Notice of Intent Application

Addendum

Installation of two 30 ft meteorological observation towers on opposite ends of Clarks Cove

Applicant:

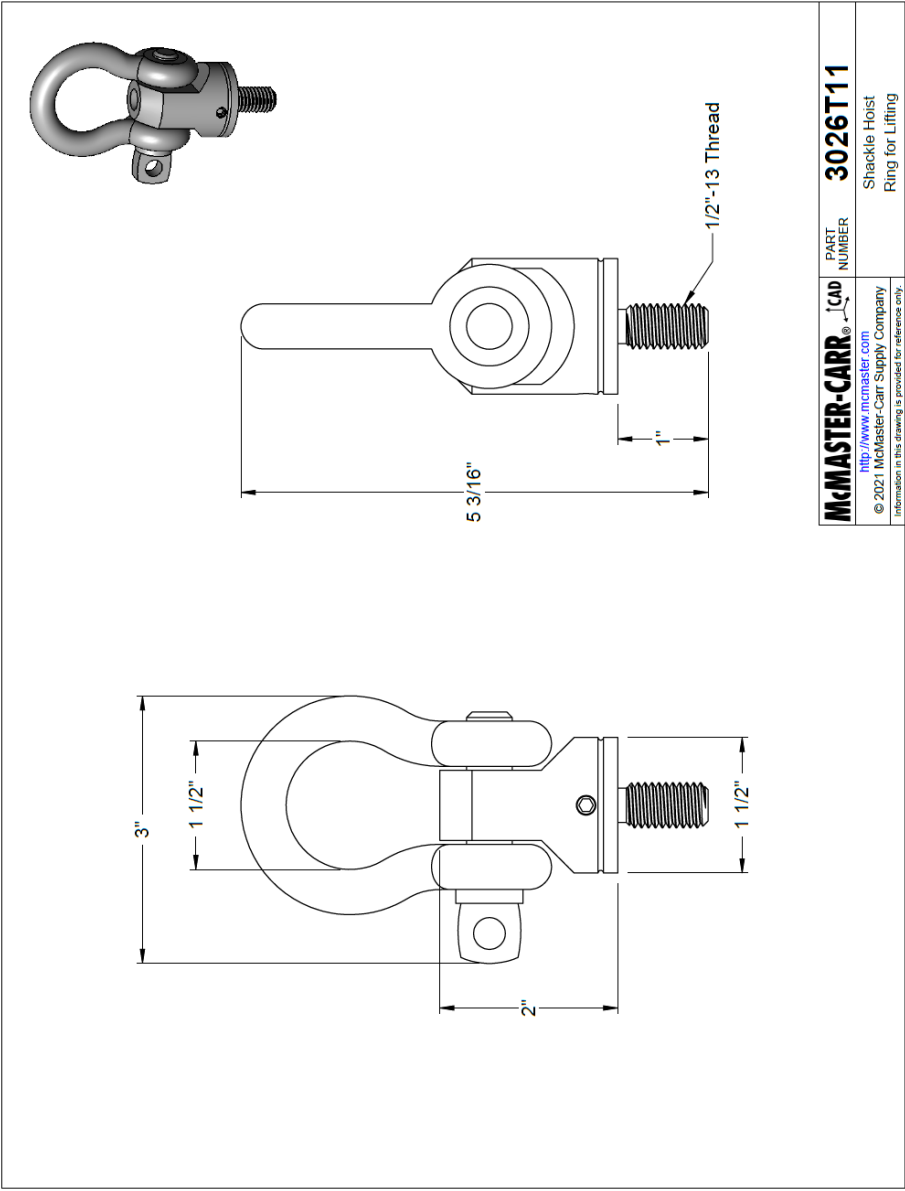
- **Provide a plan for how to secure and/or remove towers during major storm, including how to secure towers once tilted down. Even if the bases of the towers remain anchored, still need 30' end anchored/fastened in some way at both sites. Of particular concern is how the SMAST tower will be secured, either to rail or lying flat on pier.**

The project's licensed P.E. subcontractor, Waterfront Structural Consulting, LLC, has added to the tower installation drawing notes details regarding a "Heavy Weather Plan." For the SMAST location, this includes prescription of how to lower the tower to a horizontal position by removing a removable section of guard rail on the pier and securing the tower to rail brackets using 1,000 lb ratchet straps. For the Community Boating Center location, the notes including prescription of how to secure the tower using 1,000 lb ratchet straps to a stainless drop-in anchor point on the concrete deck that has been added to the construction design. Revised notes are attached on the following pages, and will be incorporated into the final design drawings for installation of the towers at the two proposed locations. Manufacturer drawings for the prescribed concrete anchor points and screw-eye are also included for reference. Additionally, the final hurricane preparation plan for tower decommissioning will be added to the existing UMassD/SMAST Severe Weather Plan in consultation with the SMAST Assistant Dean for Operations, and SMAST Facilities Manager. Finally, in addition to securing the towers themselves, the severe weather plan will include removing from the tower structures all electronics, batteries and sensors not specifically designed to withstand severe weather.

1. When winds are forecast to exceed 100 MPH within 48 hours, the following procedure shall be taken by SMAST to secure the towers.
 - a. Lower the tower to horizontal position with winch.
 - b. Support tower on timber blocking in a level position.

- c. At the Pier supported tower
 - i. Remove guard rail obstructing laydown of tower.
 - ii. Secure tower with 1000 lb. ratchet straps to the pier structure using the guard rail brackets.
 - iii. Store the removed guard rail indoors.
 - iv. Provide rope across the removed section of guard rail
- d. At the Jetty supported tower
 - i. Secure the tower with 1000 lb. capacity ratchet straps to stainless steel drop-in anchor point on concrete deck.
